Parker Creek  
07-0001 S

**STATE OF MARYLAND  
CRITICAL AREA COMMISSION  
CHESAPEAKE AND ATLANTIC COASTAL BAYS**

Re: Parker Creek  
S-05-014, P-07-0153

Thank you for forwarding the above referenced final subdivision submittal. The project consists of the subdivision of an existing 2.66 acre lot into five lots, removal of an existing dwelling, driveway, shed, and pool, and construction of five new dwellings, and driveways on each of the proposed lots. Within the 2.66 acre property, 0.35 acres are designated as a Resource Conservation Area (RCA) and 2.31 acres are designated as a Limited Development Area (LDA).

SWM PRACTICE PLAN  
 OF THE FINAL DEVELOPMENT PLANS FOR  
**PARKER CREEK**  
 A MAJOR SUBDIVISION  
 TAX ACCOUNT # 07-000-0136010  
 TAX MAP 78, GRID 2, PARCEL 308  
 DEALE, MD 20751 - ZONED: R-3 AND OS  
 SEVENTH DISTRICT - ANNE ARUNDEL COUNTY, MD

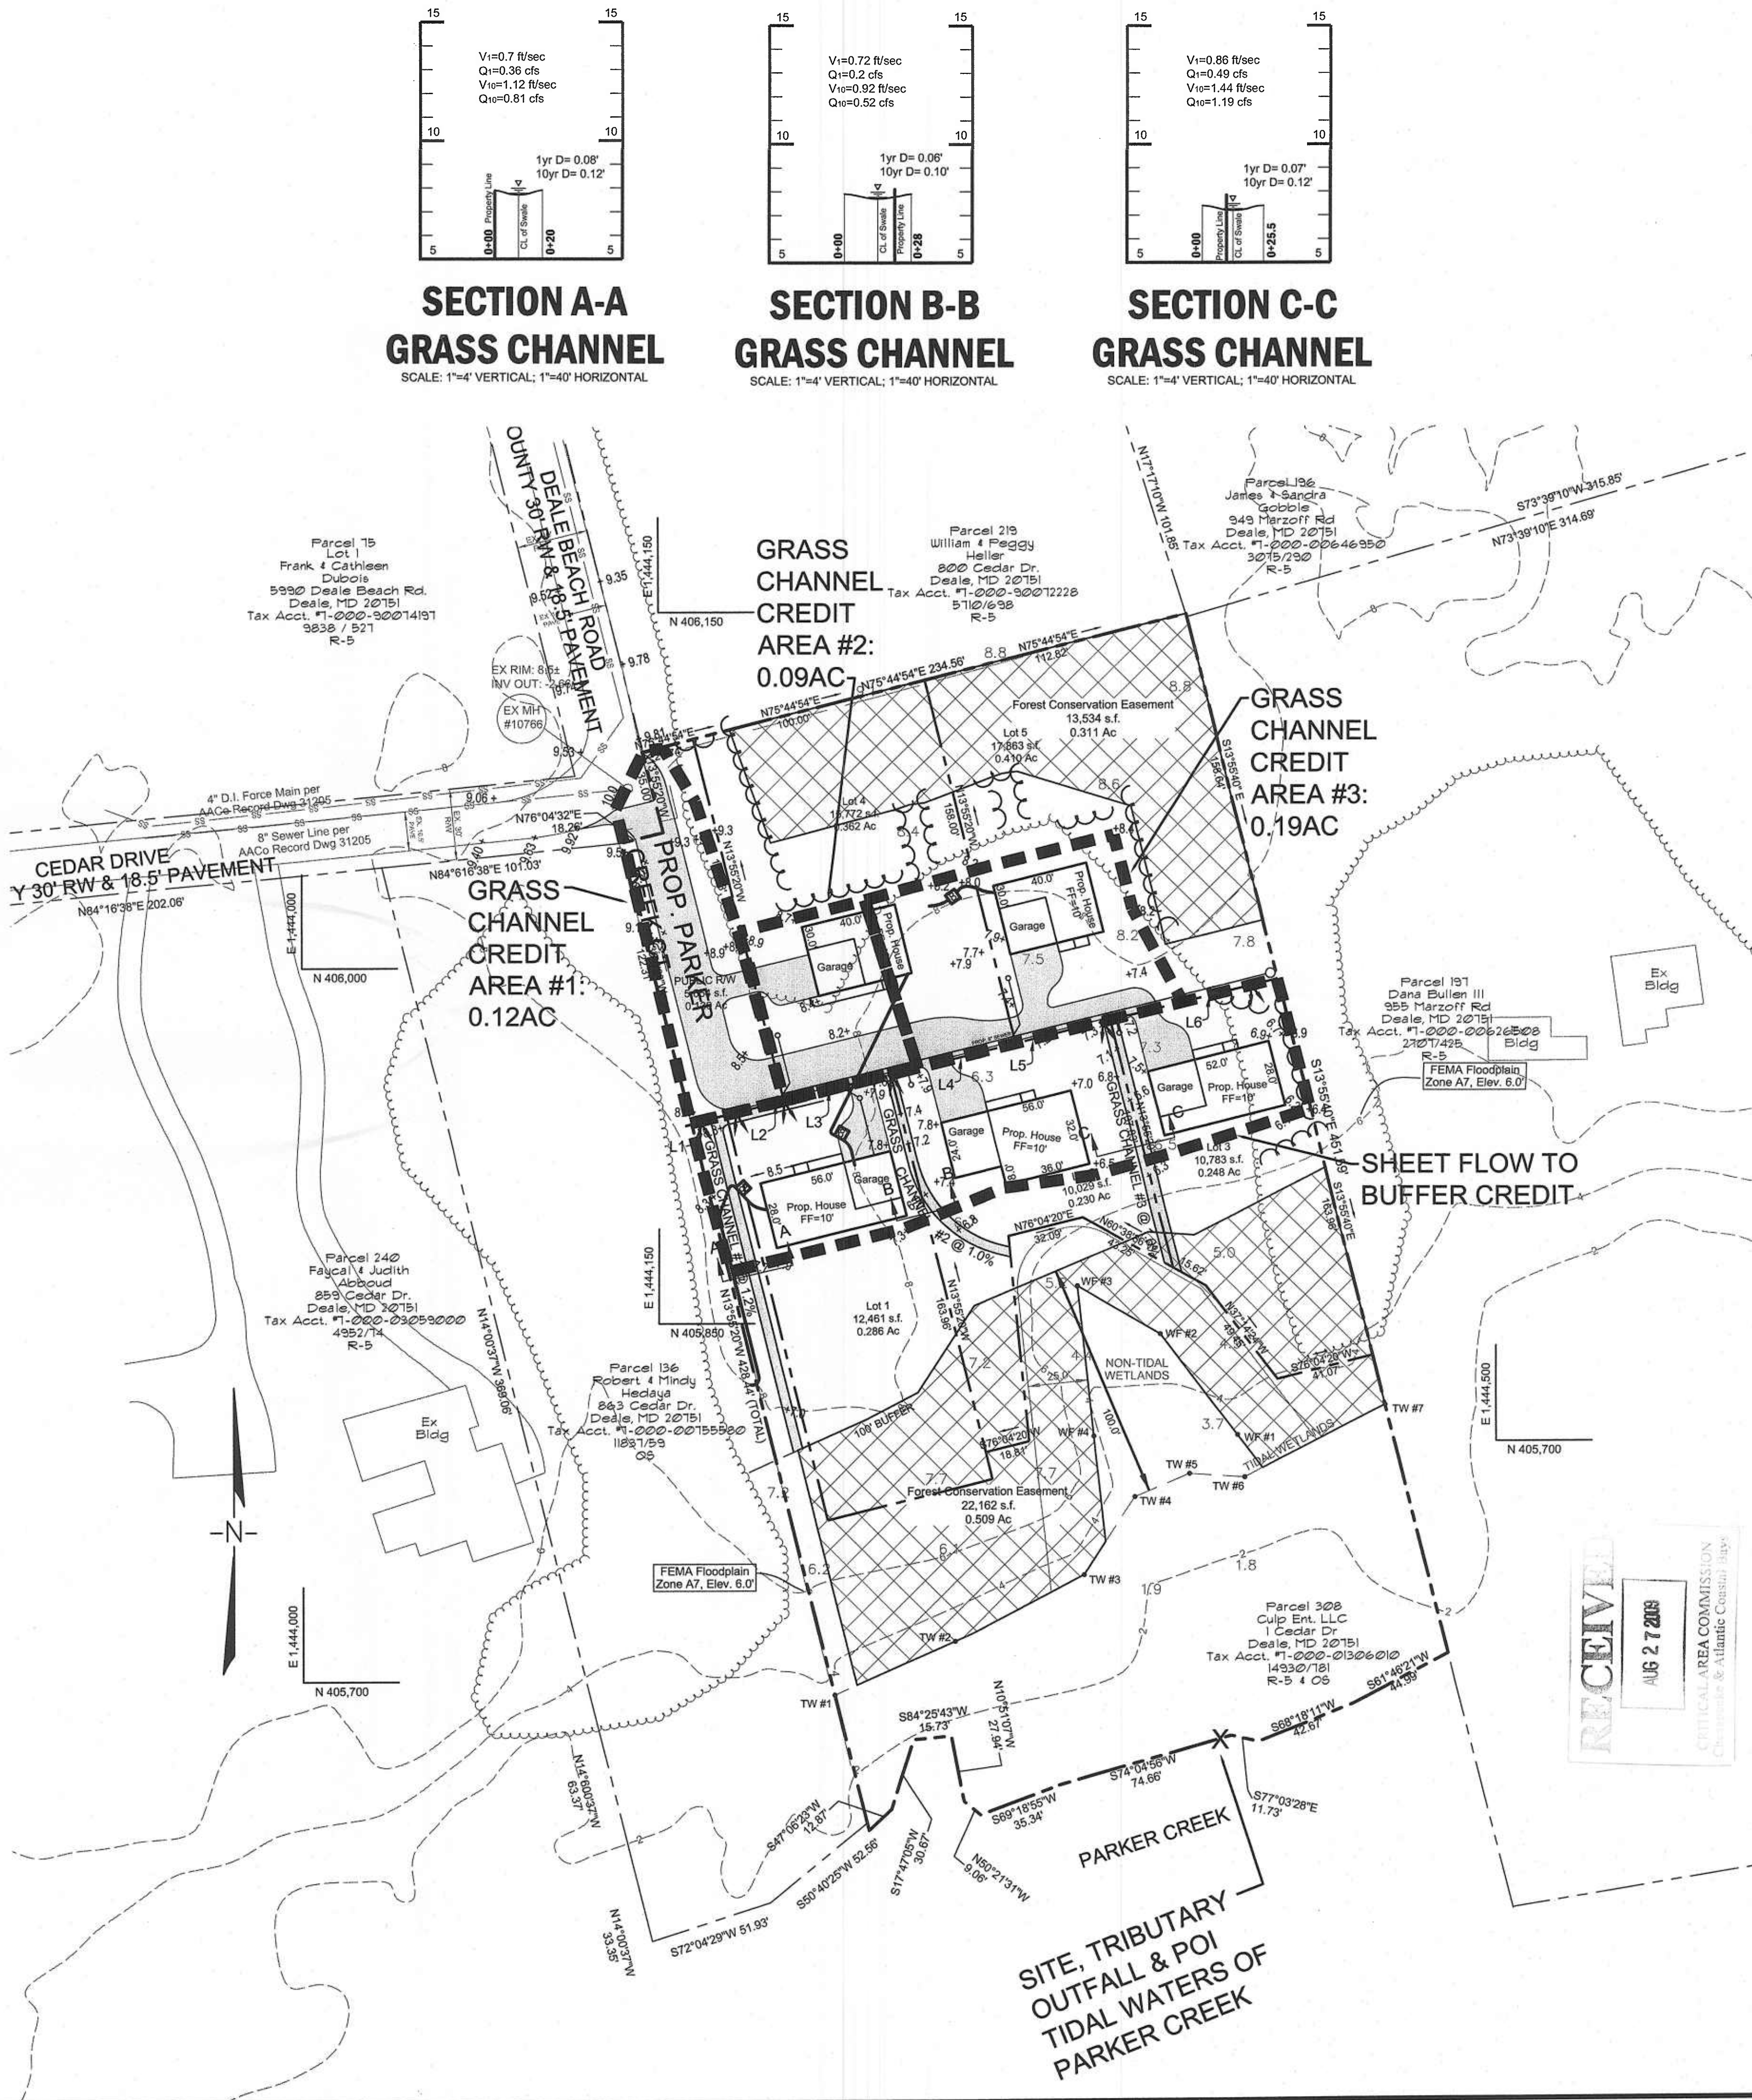
1. Comment noted; the site, tributary, and POI drainage area outfall points are shown on the SWM practice plan of the final development plans. Time of concentration flow paths and TR55 computations for each drainage area have been included in the SWM report.

### REFORESTATION STATEMENT

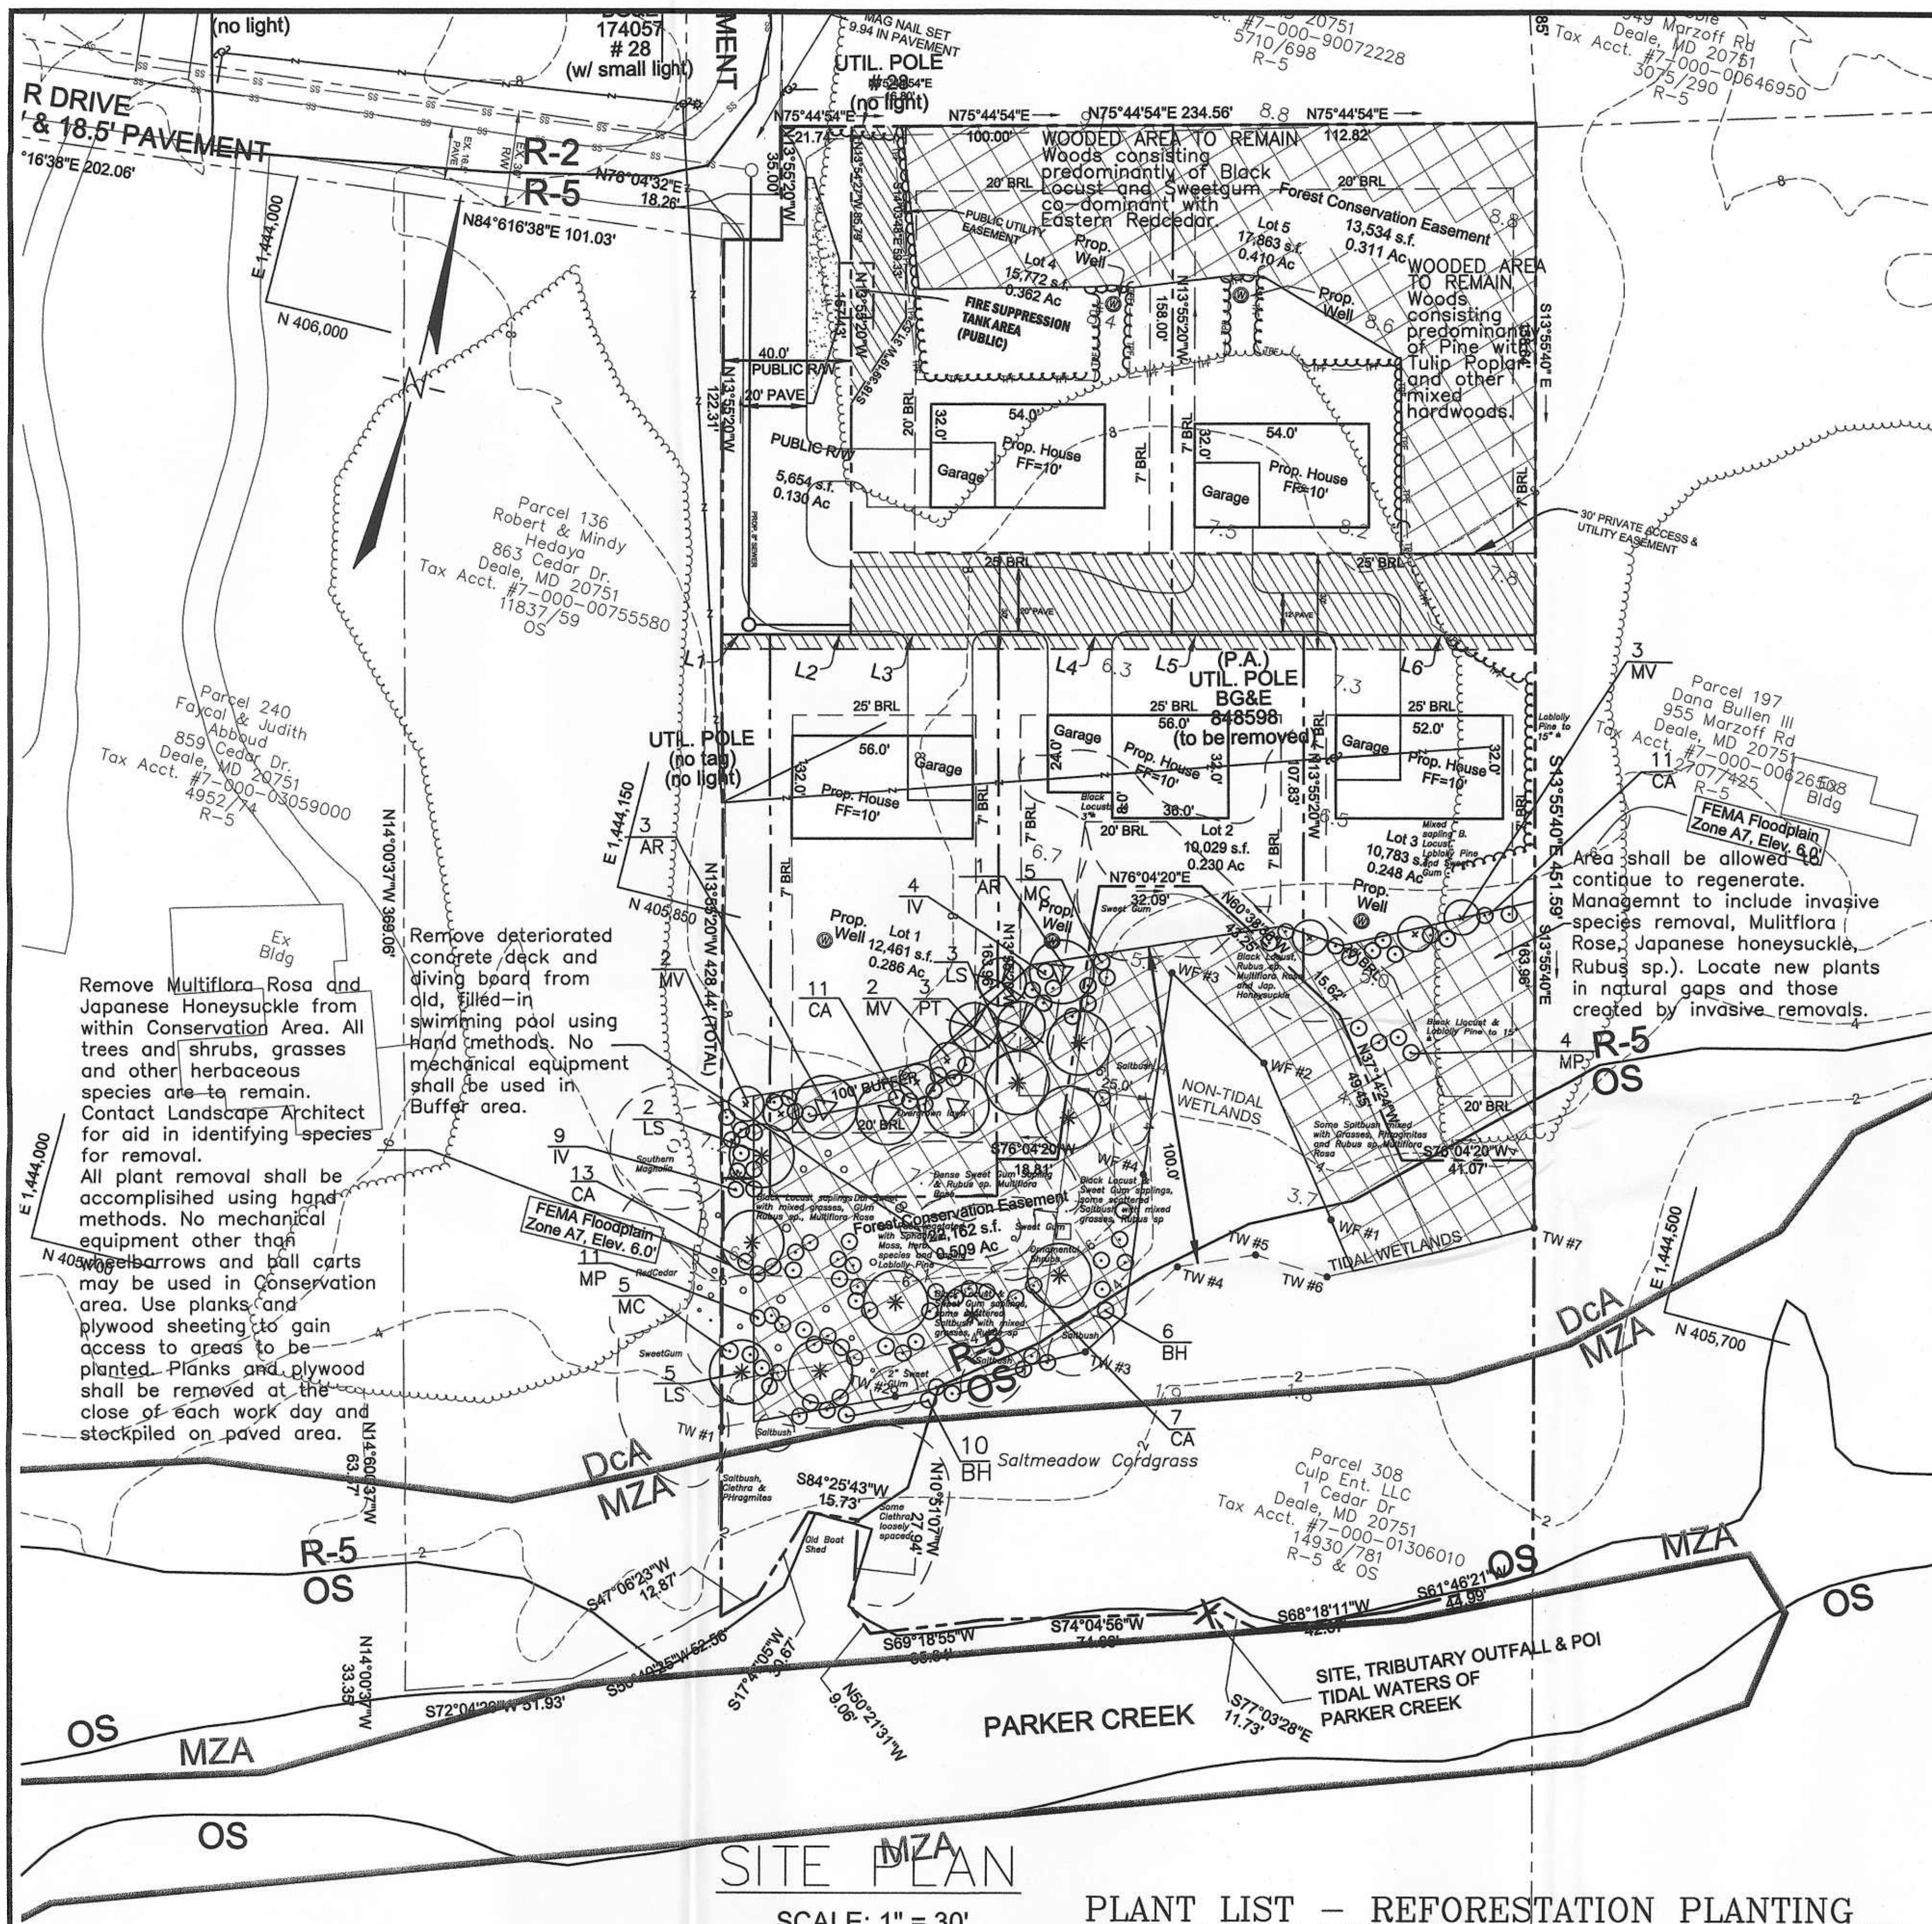
- 5) The plans show the planting area for the forest clearing mitigation in the tidal wetlands. Mitigation requirements for clearing upland vegetation cannot be met by planting wetland species. Therefore, the applicant can not use this area to do reforestation mitigation plantings and must locate the reforestation plantings somewhere other than the tidal wetlands on the property.

- 2) We note that the applicant proposes to provide the required reforestation on-site in the 100-foot Buffer as is typically recommended. However, the applicant only proposes reforestation plantings in the portion of the Buffer that is mapped as tidal wetlands. Buffer plantings that meet the reforestation requirement must consist of woody, upland species of plants. This can be a combination of canopy, understory and herbaceous plants. It is unclear how these upland plantings will

survive in a tidal wetland. Accordingly, we recommend that the reforestation area be located in the portion of the Buffer that is not a tidal wetland, and the applicant may provide additional tidal wetland plantings in the tidal wetland if these will not disturb the existing tidal wetland vegetation and habitat; however, these plantings may not be counted towards meeting our planting requirements. All proposed plantings must be shown in a buffer management plan and the plan should be submitted to the Commission and the County.

The area proposed for reforestation is 22,162sf. Since the date of the Critical Area report and the original date of this plan submission, significant regeneration has taken place, for the most part, Black Locust. The approximate existing vegetation has been shown hereon, per 12-15-08.

The proposed reforestation is reduced to reflect this regeneration. Infill planting is proposed with species as found on site and suitable for tidal wetland areas. Management and monitoring of invasive vines is also proposed.
